Final EIR/EIS  
Volume II  
Folsom South of U.S. Highway 50 Specific Plan Project

SCH #2008092051

## **INDIVIDUAL COMMENTERS**

**Swainson's Hawk Foraging Habitat Within Swainson's Hawk Nest Buffer**  
 2005-429 Folsom Plan Area Specific Plan

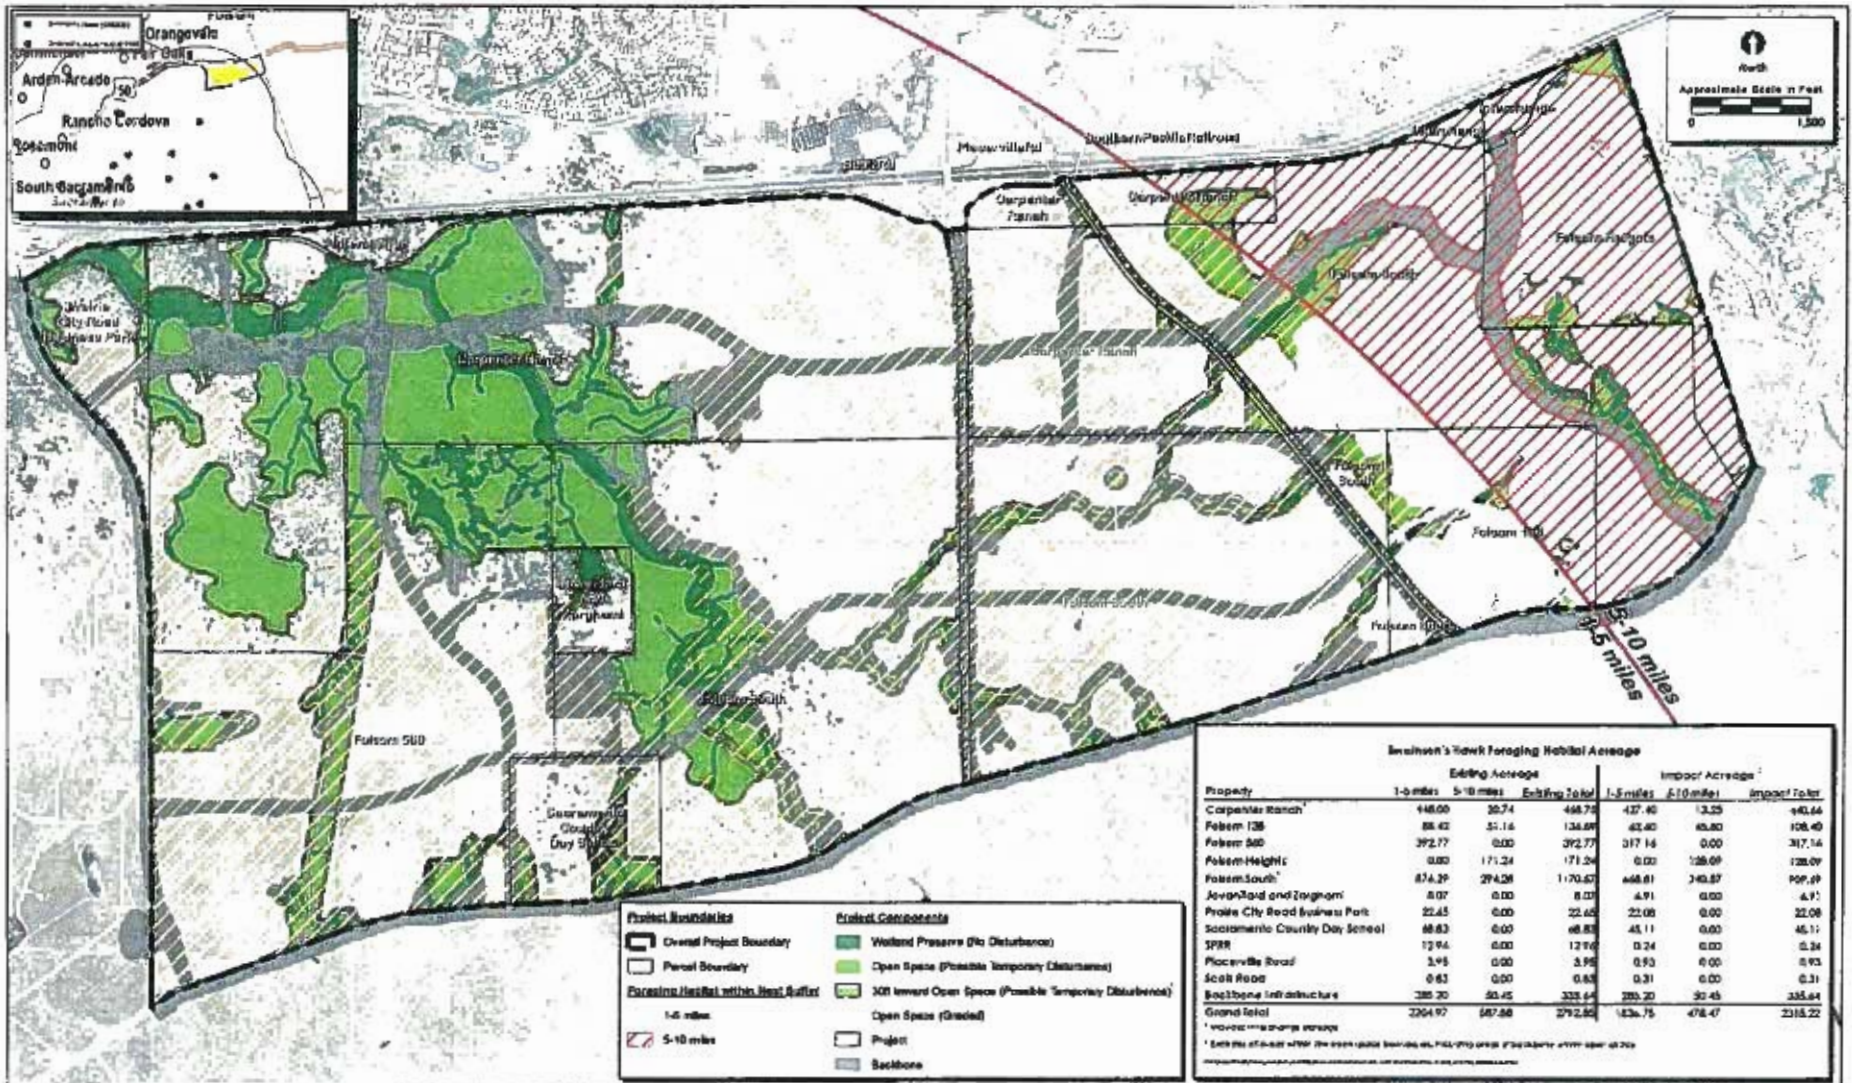
*The comment refers to Exhibit 3A.3-2 on page 3A.3-15 and states that the Swainson's hawk occurrence (at the center of the project along White Rock Road) is a 28-year-old, single-soaring observation, not a nest. The comment further states that the closest known nest is 2 miles to the southwest and requests that Exhibit 6 (attached to commenter's letter) be reviewed.*

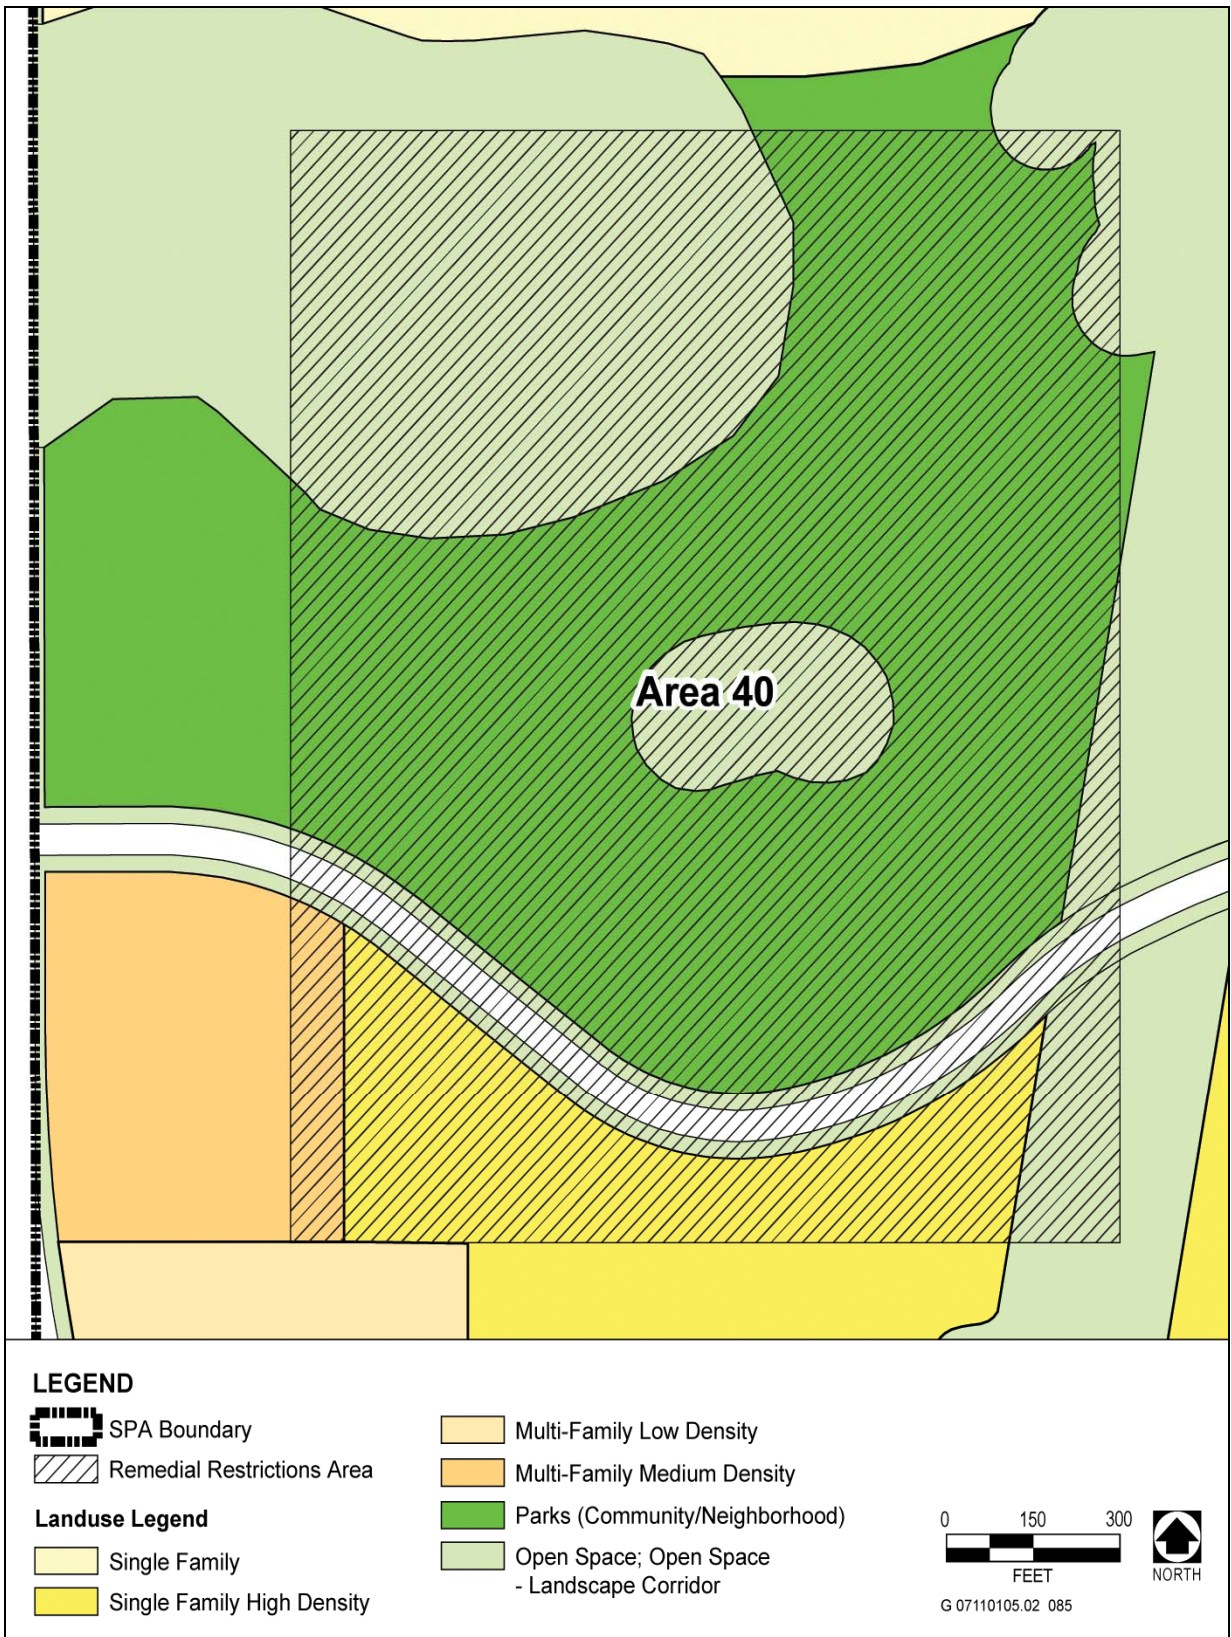
Prior to approval of any tentative maps, improvement plans, or discretionary project approvals for locations within Area 40, as depicted in the Remedial Restrictions Area (Exhibit 3A.8-9), the project applicant(s) shall designate those areas that are subject to off-gassing hazards in excess of an indoor air

The text under Mitigation Measure 3A.8-6 on page 3A.8-32 is hereby revised as follows:
